Access Compliance Report Public Rights-of-Way (Curb Ramps)

Intersection ID: 12779 Main Street: E_TRADE_ST Cross Street: S_DAVIDSON_ST Location: S

ADA ID: DE6A942E5B6F Ramp Type: Perp Initial Pass/Fail: Fail Overall Compliance: No Severity Score: 12.5

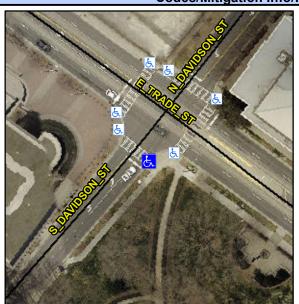
Not Found, R304.2.2

Field Measur	ements/C	ompo	nent Compliance	
Compliance Description		Data	Compliance Description		Data
N/A	Ramp Length (in)	78.0	No	Ramp Slope (%)	8.4
Yes	Ramp Width (in)	48.0	Yes	Ramp XSlope (%)	1.3
N/A	Flare Type LT	N/A	N/A	Flare Type RT	N/A
N/A	Flare Slope LT (%)	N/A	N/A	Flare Slope RT (%)	N/A
N/A	Flare Traversable LT?	N/A	N/A	Flare Traversable RT?	N/A
N/A	Landing Length (in)	N/A	N/A	DWS Provided?	N/A
N/A	Landing Width (in)	N/A	N/A	DWS Contrast?	N/A
N/A	Landing Slope (%)	N/A	N/A	DWS Length (in)	N/A
N/A	Landing X Slope (%)	N/A	N/A	DWS Full Width?	N/A
N/A	Landing Curb? (Y/N)	N/A	N/A	DWS Offset (in)	N/A
N/A	Shared Landing?	N/A			
N/A	Gutter Ponding?	N/A	N/A	Gutter Slope (%)	N/A
N/A	Gutter Lip Ht (in)	N/A	N/A	Gutter X Slope (%)	N/A
N/A	Painted X Walk1?	Yes	N/A	Painted X Walk2?	N/A
	X Walk 1 Direction	To NW		X Walk 2 Direction	N/A
N/A	X Walk 1 Width (in)	118.0	N/A	X Walk 2 Width (in)	N/A
	X Walk 1 Slope (%)	3.4		X Walk 2 Slope (%)	N/A

Remove & Replace Entire Ramp.
